**International
Aero Engines**

V2500 Propulsion System — Nacelle

Subject: Transmittal of Revision 3 to Service Bulletin Number V2500-NAC-71-0196

NACELLE - NOSE COWL - THERMAL ANTI-ICE DUCT INSTALLATION
MODIFICATION OF

T.A.I. Access Panel Removal/Installation
Figure 1

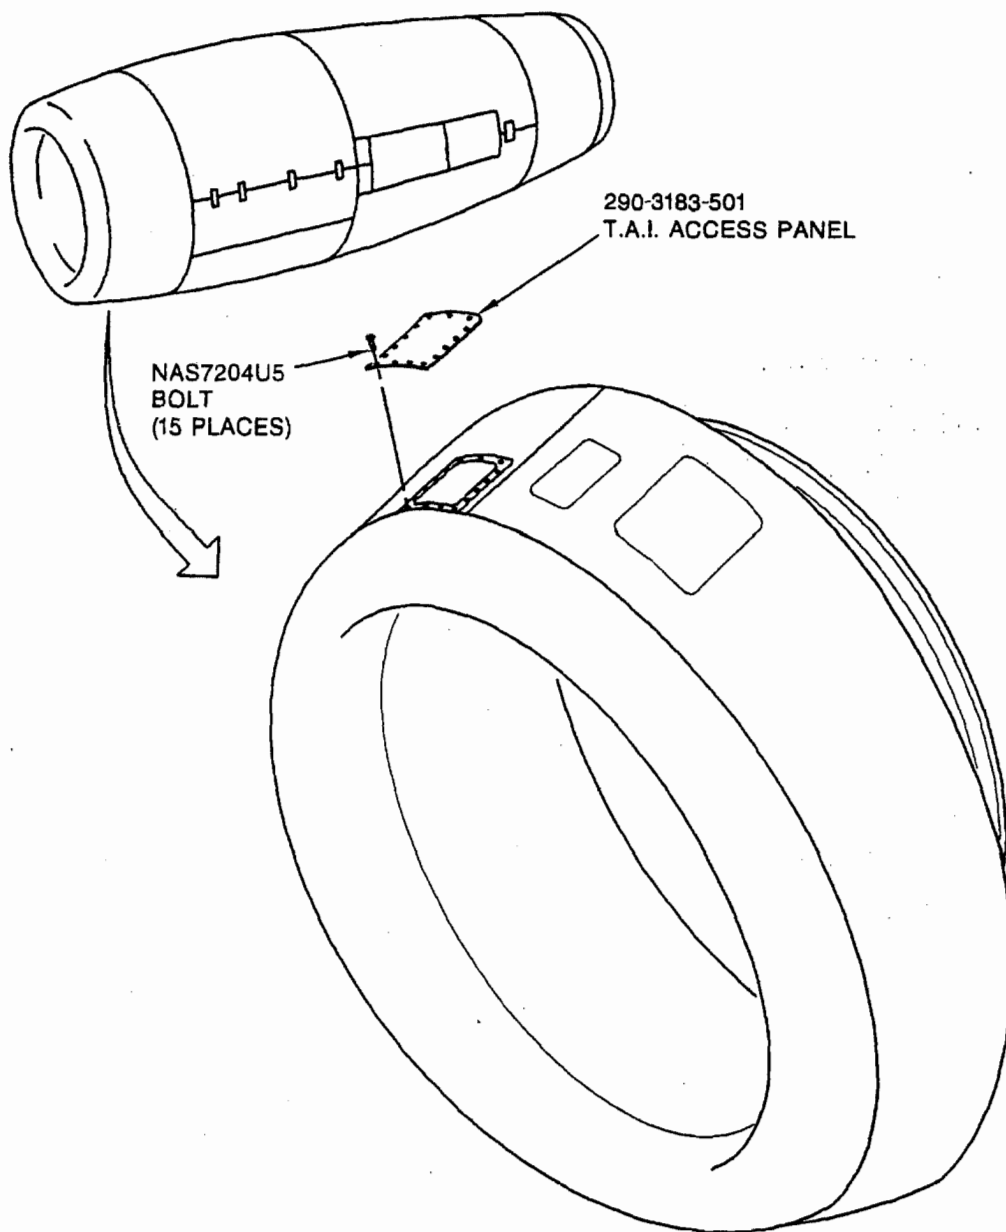
- (1) Remove the fifteen NAS7204U5 bolts and the 290-3183-501 thermal anti-ice (T.A.I.) access panel from the nose cowl. Discard any damaged bolts. Refer to Figure 1.
- (2) Open the fan cowl doors. Refer to the MD-90 Aircraft Maintenance Manual, Chapter 71-11-11, page block 201.

- (1) Install the T.A.I. access cover and fifteen NAS7204U5 attach bolts. Wet install the bolts with jointing compound (CoMat 04-005). Use new bolts if required. Tighten the bolts to a torque of 20-25 lbfin (2.26-2.82 Nm). Refer to Figure 1.
- (2) Close the fan cowl doors. Refer to the MD-90 Aircraft Maintenance Manual, Chapter 71-11-01, page block 201.

T.A.I. Duct Removal
Figure 2 (SHEET 1)

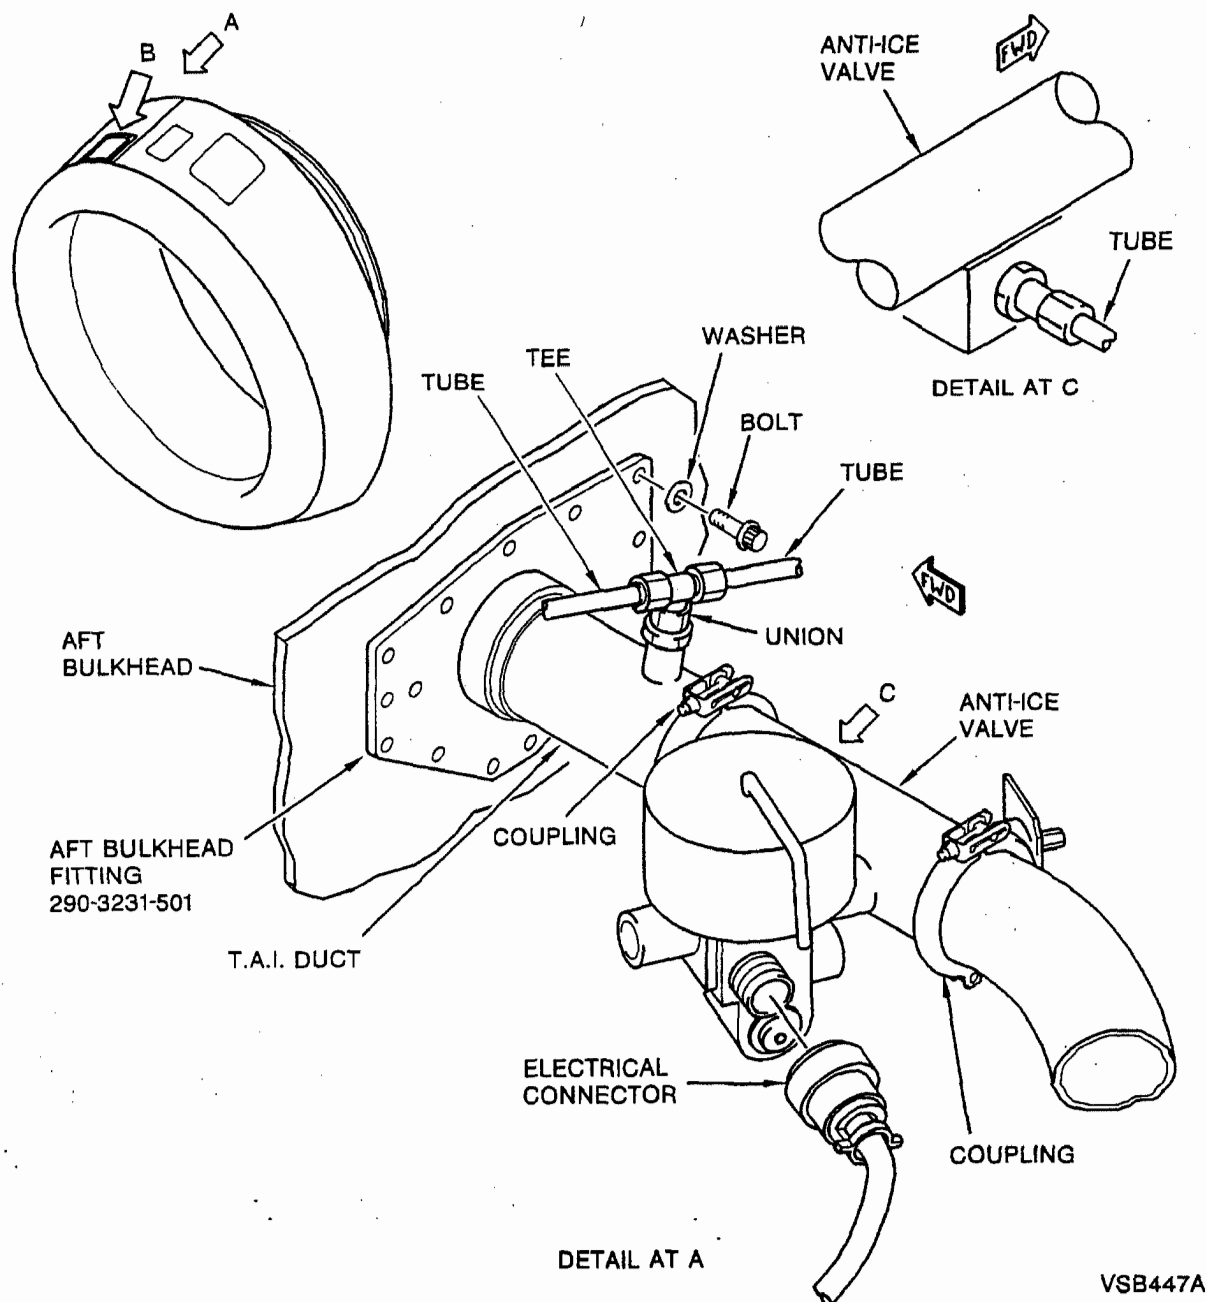
- (4) Disconnect the tubes from the tee on the T.A.I. duct just aft of the rear bulkhead. Then loosen the union and remove the tee. Refer to Figure 2 (Sheet 1).
- (5) Disconnect the tube from the anti-ice valve.
- (6) Disconnect the electrical connector from the anti-ice valve.

- (20) Install the tee in the T.A.I. duct. Tighten the union to a torque of 200-250 lbfin (23-28 Nm). Refer to Figure 2 (Sheet 1).
- (21) Install the tubes on the tee. Tighten the b-nuts of the tubes to a torque of 200-210 lbfin (23-24 Nm).

T.A.I Duct Removal
Figure 2 (Sheet 2)

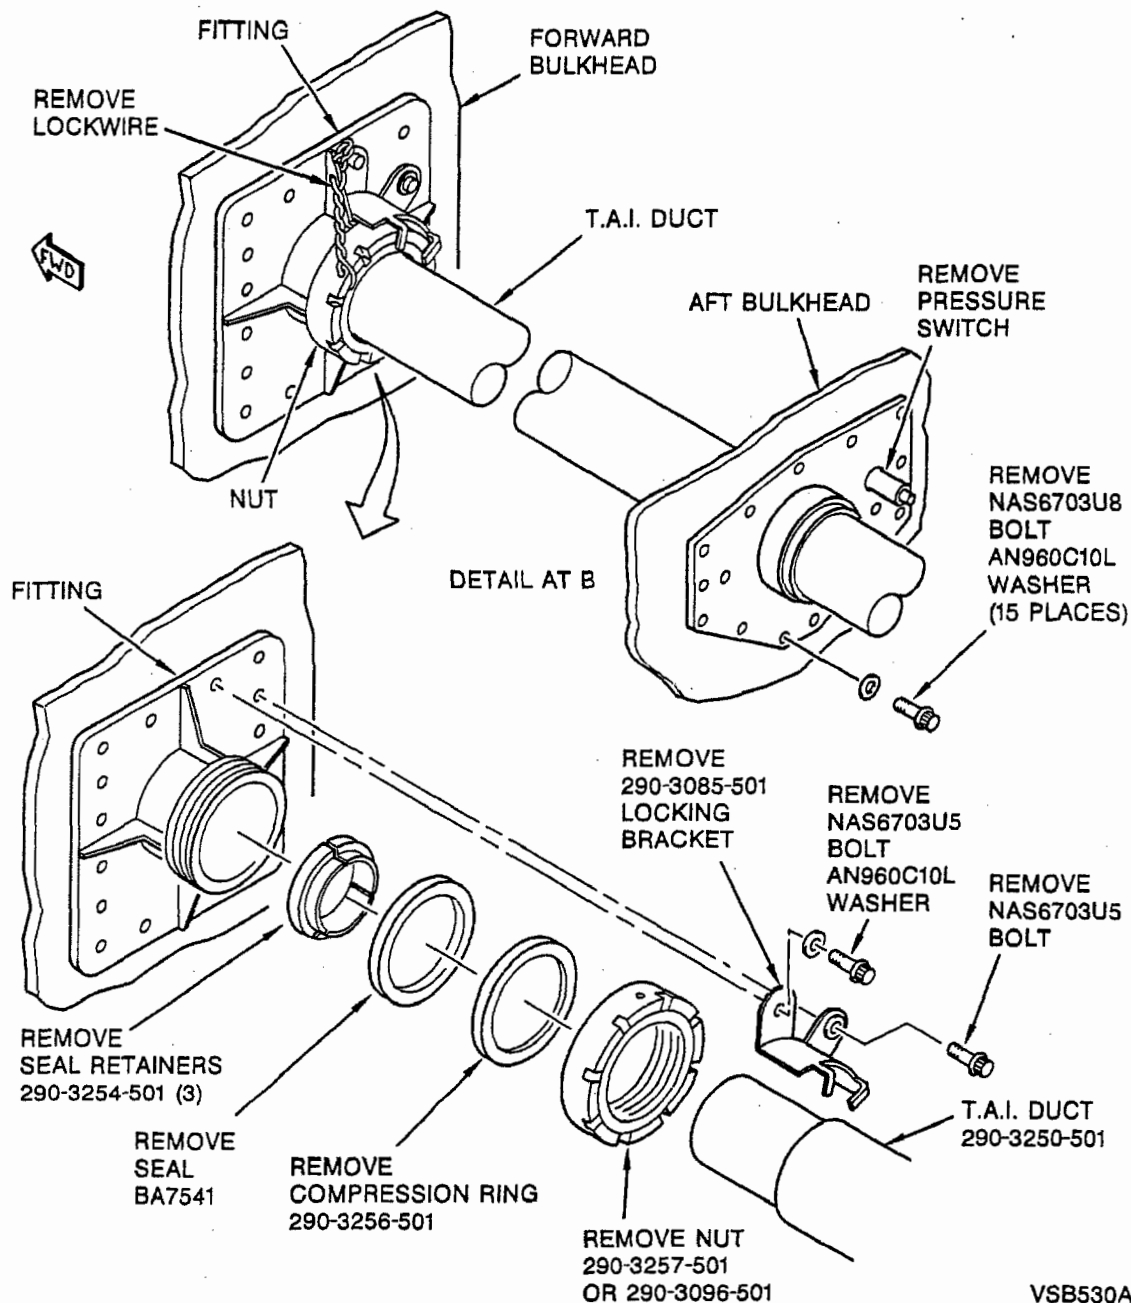
- (1) Remove the lockwire and the 290-3085-501 retention bracket from the 290-3257-501 or 290-3096-501 T.A.I. duct coupling nut. Refer to Figure 2 (Sheet 2).
- (2) Loosen and disconnect the coupling nut from the forward bulkhead fitting. Use the IAE 1N20033 spanner wrench.
- (3) Carefully remove the 290-3254-501 three-piece retainer from around the forward end of the T.A.I. duct. Discard retainers.

- (7) Remove the two couplings, two e-seals and anti-ice valve from the T.A.I duct.
- (8) Remove the fifteen NAS6703U8 bolts and AN960C10L washers that attach the T.A.I duct and the 290-3231-501 support bracket to the aft bulkhead. Refer to Figure 2 (Sheet 2).

- (9) Pull the T.A.I duct from the nose cowl aft bulkhead far enough to remove the BA7541 seal, 290-3256-501 compression ring, and coupling nut. Refer to Figure 2 (Sheet 2).

T.A.I. Duct Installation Modification
Figure 3 (Sheet 1)

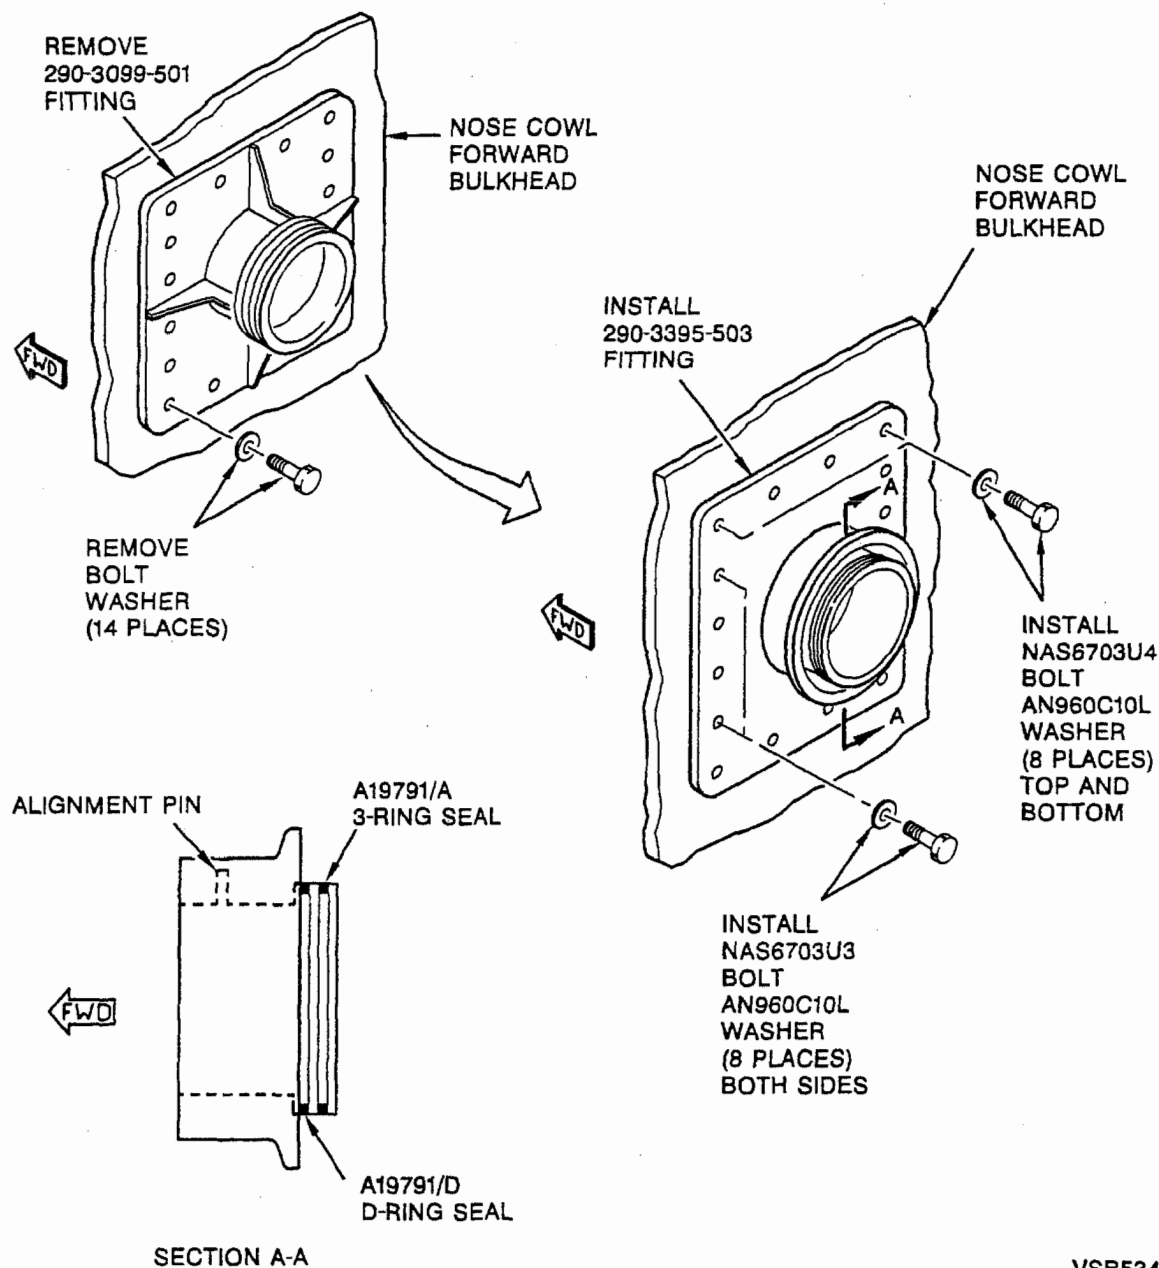
- (10) Remove the T.A.I. duct aft through the nose cowl aft bulkhead.
- (11) Remove the seven NAS6703U3, seven NAS6703U4 bolts, fourteen AN960C10L washers, and the 290-3099-501 forward bulkhead fitting. Discard the forward bulkhead fitting. Cover the opening to make sure no contaminants are allowed to enter. Refer to Figure 3 (Sheet 1).

- (6) Apply jointing compound to the eight NAS6703U3 bolts, the eight NAS6703U4 bolts, and mating surfaces of the 290-3395-503 forward bulkhead fitting and the forward bulkhead. Refer to Figure 3 (Sheet 1).

- (7) Install the new 290-3395-503 forward bulkhead fitting with eight NAS6703U3 bolts, eight NAS6703U4 bolts, and sixteen AN960C10L washers. Torque the bolts to 40 in-lbs (4.52 Nm). Refer to Figure 3 (Sheet 1).
- (8) Install the 290-3416-501 inner duct and then the 290-3417-503 outer duct on the forward bulkhead. Make sure the seals remain in proper position during duct installation.

T.A.I. Duct Installation Modification
Figure 3 (Sheet 2)

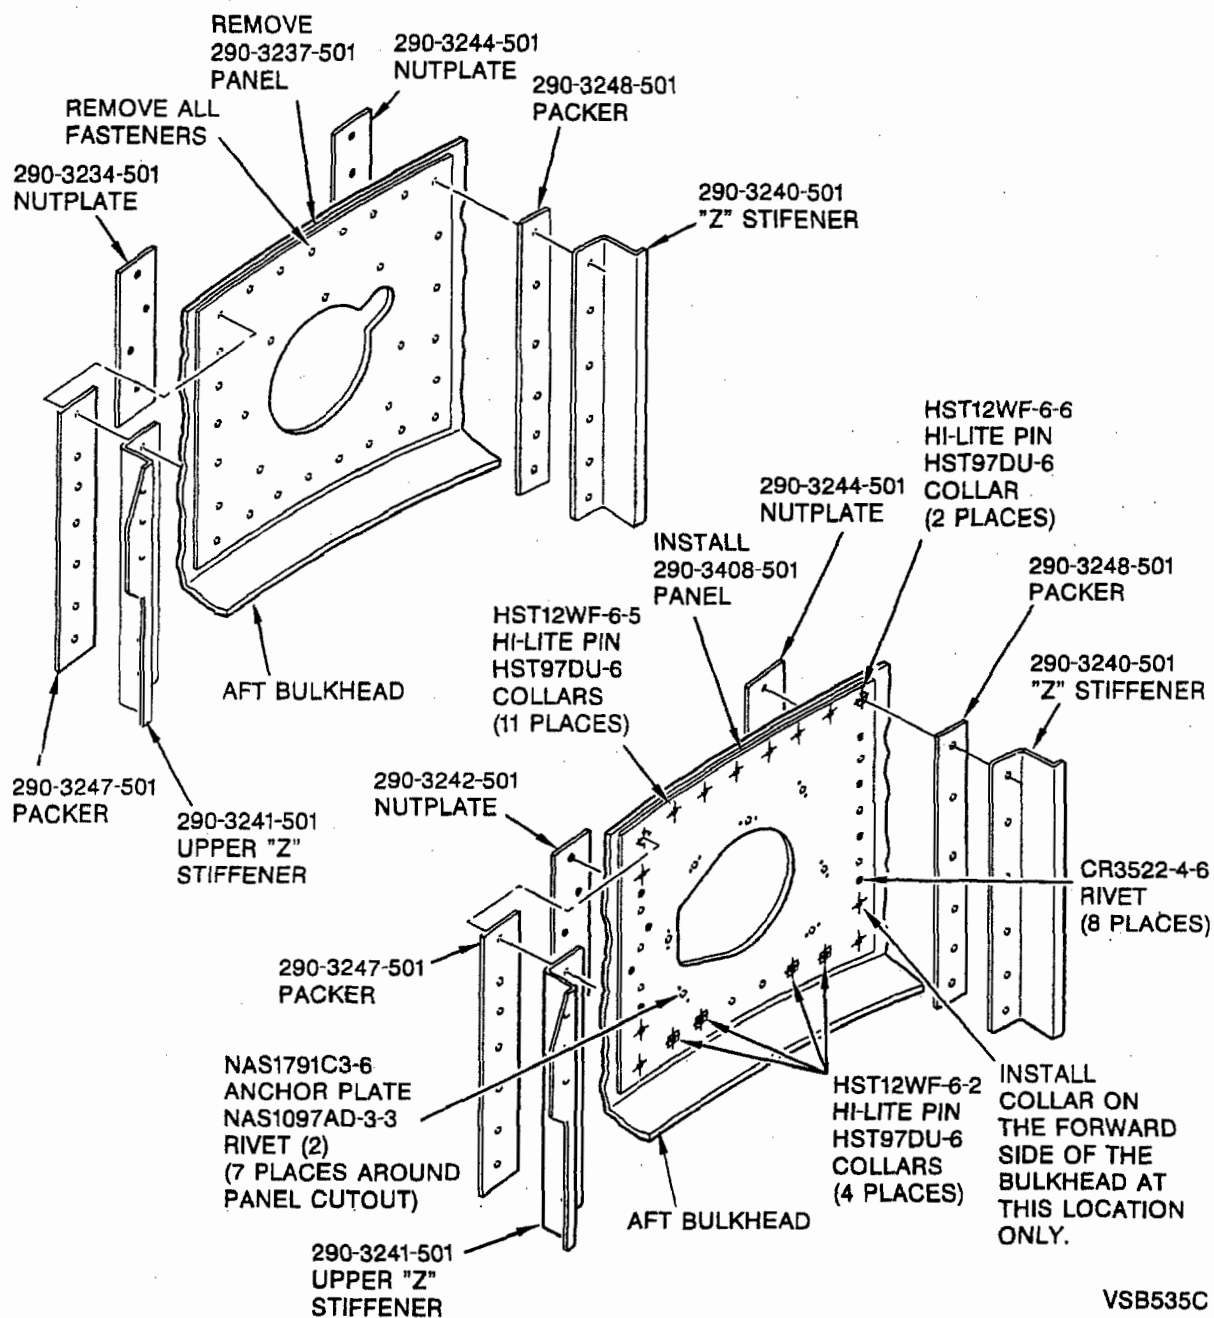
- (12) Remove the seventeen hilite fasteners, eight rivets, 290-3240-501 and 290-3241-501 stiffeners, 290-3237-501 T.A.I. aft bulkhead panel, 290-3247-501 and 290-3248-501 packers, and the 290-3242-501 and 290-3244-501 nutplates from the aft bulkhead. Refer to Figure 3 (Sheet 2).

- (1) Drill the holes in the 290-3408-501 aft bulkhead panel. Use the 290-3237-501 panel as a template. Refer to Figure 3 (Sheet 2).
 - (a) Hold the 290-3237-501 and 290-3408-501 aft bulkhead panels together with clamps. Make sure the panels are aligned.

- (2) Install seven NAS1791C3-6 nutplates with fourteen NAS1097AD-3-3 rivets. Wet install the rivets with jointing compound (CoMat 04-005).
- (3) Apply jointing compound (CoMat 04-005) to the mating surfaces of the 290-3408-501 aft bulkhead T.A.I. panel, the packers, the stiffeners, the nutplates and the aft bulkhead. Refer to Figure 3 (Sheet 2).

- (4) Install the nutplates, the packers, the T.A.I. panel, and the 290-3240-501 and 290-3241-501 stiffeners on the aft bulkhead with four HST12WF-6-2 pins, eleven HST12WF-6-5 pins, two HST12WF-6-6 pins, seventeen HST97DU-6 collars, and eight CR3522-4-6 rivets. Wet install the fasteners with jointing compound (CoMat 04-005). Install all but one of the hi-lite fasteners with the collars on the aft side of the aft bulkhead. Refer to Figure 3 (Sheet 2).

T.A.I. Duct Installation Modification
Figure 3 (Sheet 3)

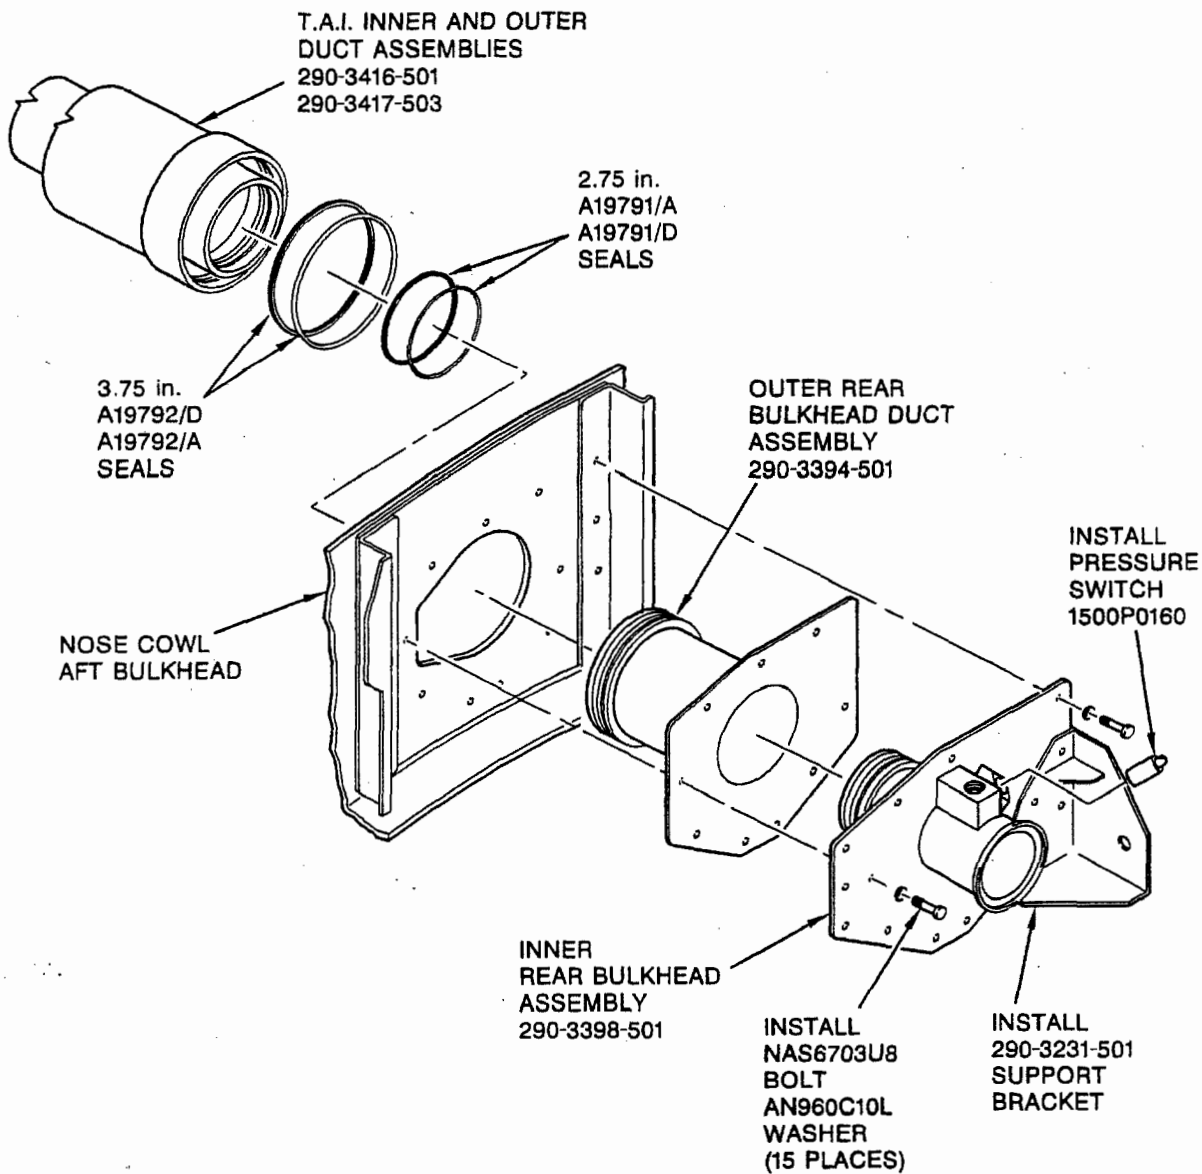
- (10) Install the 3.75 inch (95.25 mm) diameter A19792/D D-ring seal (aft most recess on the 290-3394-501 aft outer duct assembly) and 3.75 inch (95.25 mm) diameter A19792/A 3-ring seal, (forward most recess on the outer duct assembly). Refer to Figure 3 (Sheet 3). Make sure the gaps in the 3-ring seal are not aligned with one another.

- (12) Apply jointing compound (CoMat 04-005) to the mating surfaces of the 290-3394-501 outer rear bulkhead duct assembly and the 290-3398-501 rear bulkhead assembly. Refer to Figure 3 (Sheet 3).

- (13) Put the 290-3394-501 outer rear bulkhead duct assembly on the aft end of the 290-3417-503 duct. Put the 290-3398-501 rear bulkhead assembly on the 290-3416-501 duct. Make sure the attach holes of the two fittings align. Refer to Figure 3 (Sheet 3).

- (19) Install the 290-3231-501 support bracket on the rear bulkhead fitting with four NAS6703U8 bolts and AN960C10L washers. Torque the bolts to 40 in-lbs (4.52 Nm). Refer to Figure 3 (Sheet 3).

- (23) Install the tube on the anti-ice valve.
- (24) Install the electrical connector on the anti-ice valve.
- (25) Install the pressure switch in the boss on the anti-ice duct. Torque the switch to 60-80 lbfin (6.78-9.04 Nm.). Refer to Figure 3 (Sheet 3).
